ANC 6A Transportation & Public Space Committee Meeting

B. Public Space Permit Application #361713 for 424 11th Street Northeast, replacement of retaining wall. (15 minutes)

View Construction Permit Application Detail

Tracking #:	361713	Reviewer:	ANC 6A	Review Due Date:	03/11/2021
Permit #:				Application Creation Date:	10/27/2020
EWR #:		Assigned Tech:	Catrina Felder	Assigned Date:	10/27/2020
Permit Type:		Issue Date:			
Source Permit:		Effective Date:	12/03/2020	Expiration Date:	12/24/2020
Permit Status:	Assigned	Review Status:	Pending	Inspection Status:	Not Inspected
Archived:	✕	Locked:	✕	Renewal: ✕	Legacy: ✕
Project Name:

NEW PROPOSED RETAIN WALLS PLAN

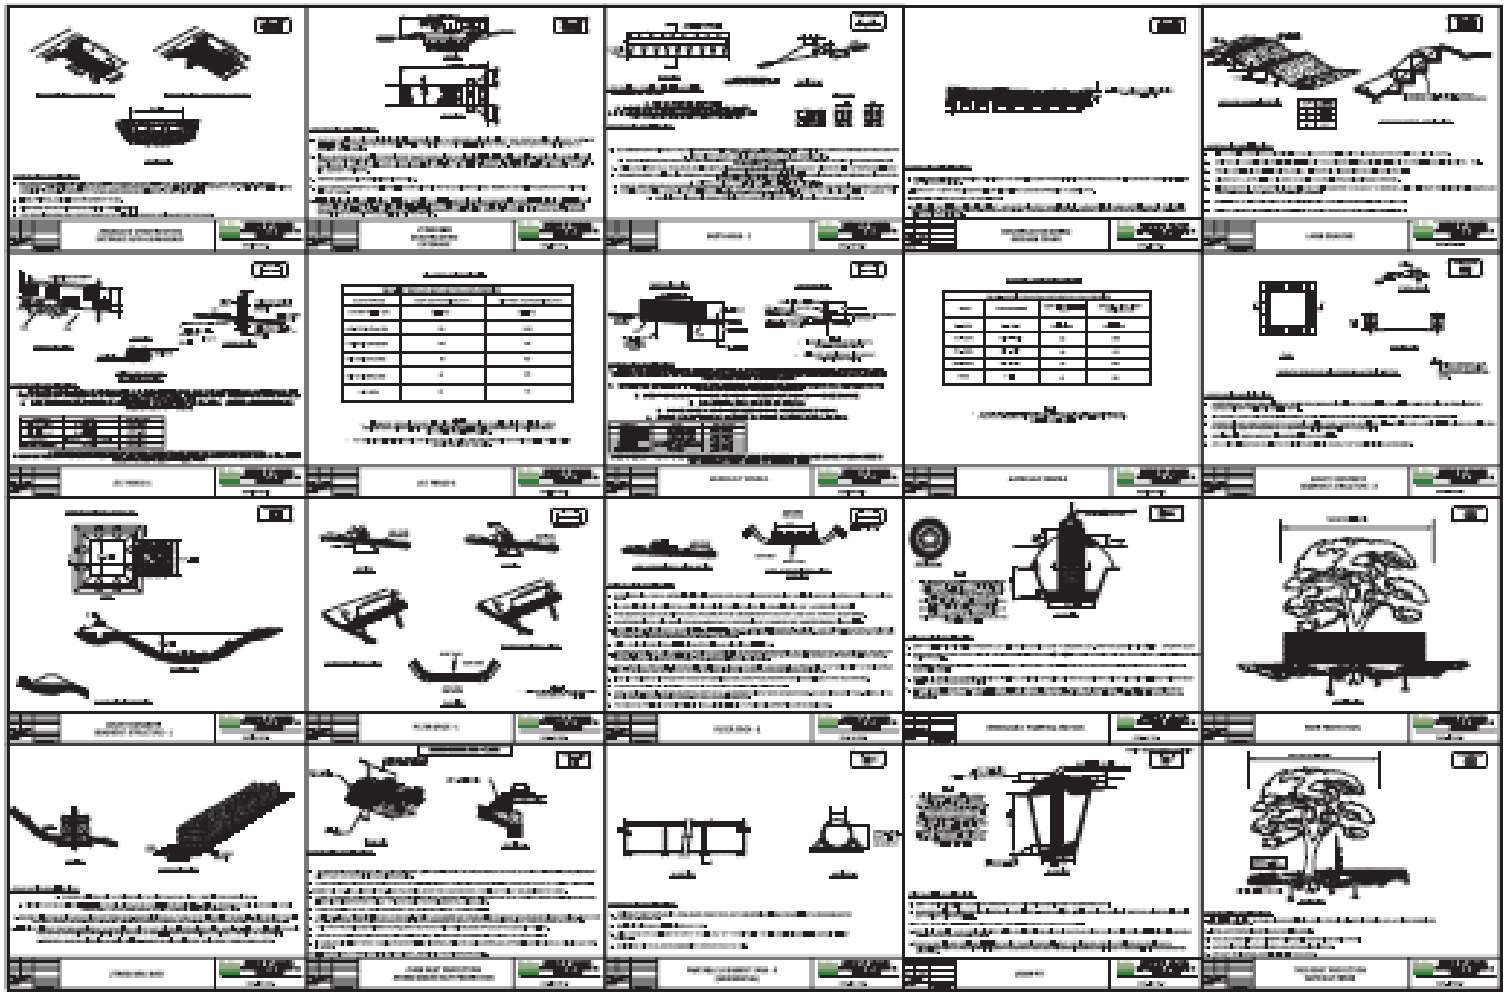
Agency	Sent Date	Return Date	Reviewer Name	Status	Util #	Notes
ANC	02/18/2021		ANC 6A	PENDING		
IPMA	02/18/2021	12/11/2020	Edwin Edokwe	PENDING		Dec 11 2020 5:31PM eedokwe wrote for Applicant - The applicant to submit Engineering design calculation for proposed retaining wall
OP-Urban Design	02/18/2021	12/11/2020	Timothy Maher	PENDING		Dec 11 2020 8:52PM tmaher wrote for Applicant - - Please provide a site plan that clearly indicates the location of the fencing and the location of the property line. Site plan should provide dimensions, and the locations of any other relevant fixtures such as street trees, sidewalk, curb line, etc. - Please provide a spec or other elevation on the design of the fencing to be installed. - Note that OP can support a fence that is a maximum of 42 inches in height and a minimum of 50% open in design if it is located in the public right-of-way.
PEPCO	02/18/2021	12/11/2020	Parker Wright	APPROVED	98905

Agency	Sent Date	Return Date	Reviewer Name	Status	Util #	Notes
WASH GAS	02/18/2021	11/30/2020	Don Srisukwattananan	PENDING	98907	Nov 30 2020 12:41AM dsrisukwattan wrote for Applicant - There is an active Washington Gas Service to 424 11th St NE within the proposed project limits, which is not shown on the plans provided and may be impacted by the proposed retaining wall. Please provide a detail of the proposed retaining wall to aid in the evaluation of potential conflicts with existing gas facilities. Washington Gas requires all active Washington Gas facilities within the project limits to be shown on the plans provided. Washington Gas requires 5 feet of horizontal separation and 12 inches of vertical separation from all underground structures. Ensure all active Washington Gas facilities within the project limits are shown on the plans provided and adjust the proposed plans if needed to accommodate 12-inch vertical separation and 5-foot horizontal separation with those facilities. If the proposed construction plans cannot be revised to allow for adequate horizontal and vertical separation with the existing Washington Gas facilities, the customer can contact the Washington Gas Customer Service department (703) 750 1000 and request a 613 order be created to relocate the service.

DOEE/SE	02/18/2021	11/24/2020	Nykia Barnes	APPROVED WITH CONDITION		Nov 24 2020 10:35AM nbarnes wrote for Applicant - If you are disturbing 50 square feet or greater of land disturbance and the construction cost exceed $9,822.29, you are required to submit an erosion and sediment control site plan to DOEE through the DCRA permitting process. https://acaprod9.dcra.dc.gov/CitizenAccess/Default.aspx Once you have applied online for the DCRA building permit, enter the project into the DOEE Surface and Groundwater System (formerly Stormwater Database). https://doee.dc.gov/swdb Soil Erosion and Sediment Control Overview https://doee.dc.gov/node/619292
IPMA/Stormwater	02/18/2021	12/11/2020	Rashed Farid	PENDING		Dec 11 2020 6:33PM rfarid wrote for Applicant - Please provide a site plan showing existing conditions and all proposed constructions. Please provide details of the retaining wall including drainage information for the retaining wall at front concerning both surface flows and weep holes to ensure that runoff must not cross property lines.
